MIAMI BEACH

Staff Report & Recommendation

SUBJECT: **PB23-0636. 1100 Fifth Street. New Office Building.**

Figure 1: Ground Floor Valet Route

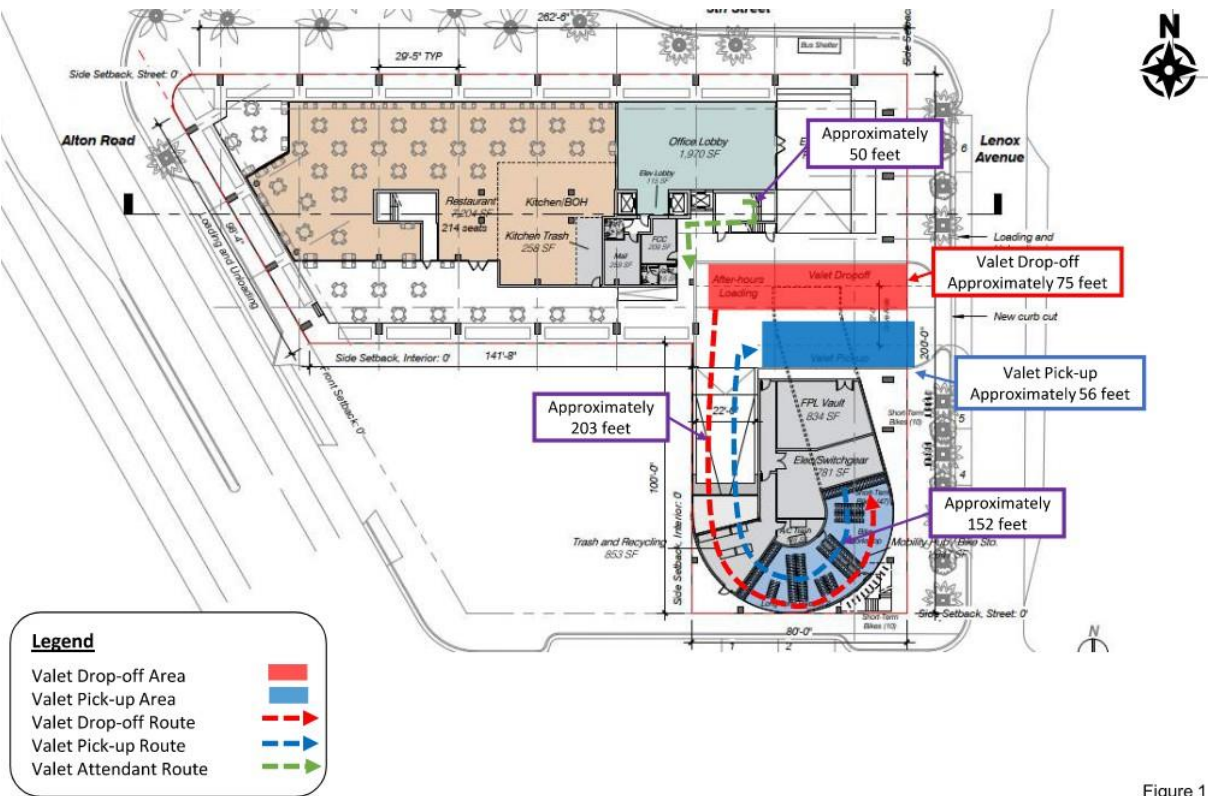
Figures 1 and 2 provide a graphic illustration of the proposed ground level valet routes to and from the on-site parking garage.

The results of the PM peak hour Valet Operations Analysis demonstrate that a minimum of eleven (11) valet attendants, five (5) for the valet drop-off area and six (6) for the valet pick-up area, would be required to ensure future valet queues do not exceed the existing storage available at the valet drop-off/pick-up area during the highest PM peak valet demand scenario.

- c. The applicant shall commit to provide the minimum number of seven (7) valet runners during the AM peak demand period and eleven (11) valet runners during the PM peak demand period. This number should be adjusted as necessary when higher than normal peak demands are encountered
